MILITARY SPECIFICATION SHEET

CAPACITORS, FIXED, CERAMIC DIELECTRIC
(TEMPERATURE COMPENSATING),
ESTABLISHED AND NON-ESTABLISHED RELIABILITY,
STYLES CCR82 and CC82

This amendment forms a part of Military Specification Sheet MIL-C-20/33A, dated 5 November 1976, and is approved for use by all Departments and Agencies of the Department of Defense.

FIGURE 1. Style CCR82 and CC82 capacitors.

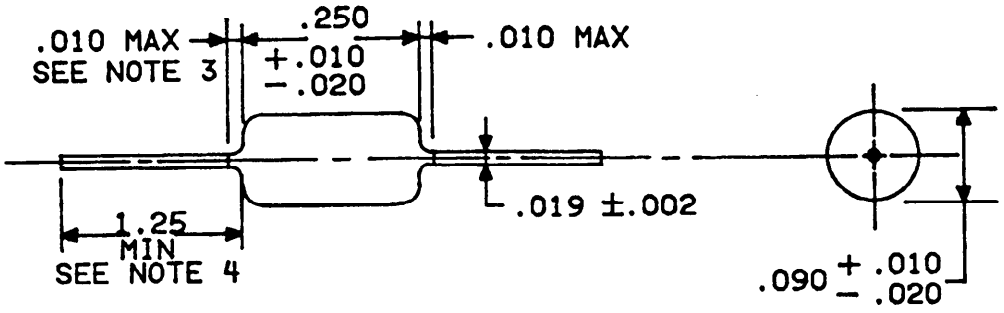
* FIGURE 1, delete and substitute:

NOTES:
1. Dimensions are in inches.
2. Metric equivalents are given for general information only and are based upon 1.00 inch = 25.4 mm.
3. Nonconductive material shall not extend more than .010 inch (.25 mm) beyond the ends of the capacitor body.
4. Lead length may be a minimum of 1.00 inch (25.4 mm) long for use in tape and reel packaging, when specified in the ordering data.
